50 & 60 HP Models – Blowing Fuses Serial Numbers 0B396036 thru 0B398982

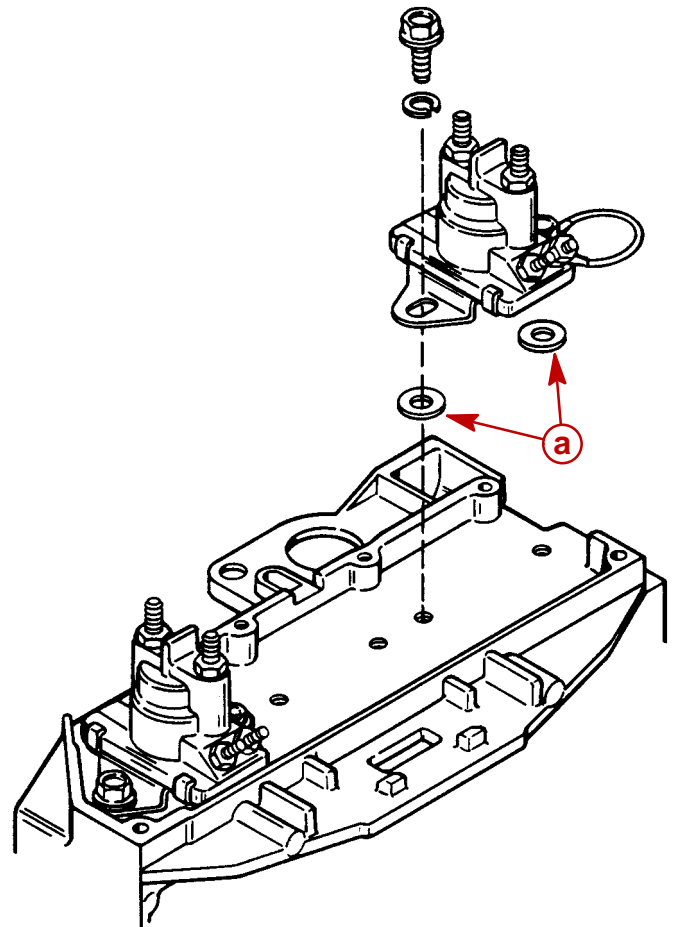
It has been determined that the solenoid terminals (on the models within the above serial number range) may contact the sound attenuator cover. If this occurs, the engine 20 amp fuse will “blow.”

To correct this problem, place 2 washers P/N 12-26020 under each solenoid to provide additional clearance. Figure 1 (opposite side). The non-power trim models require 2 washers under the starter solenoid. The power trim models have 3 solenoids and will require a total of 6 washers.
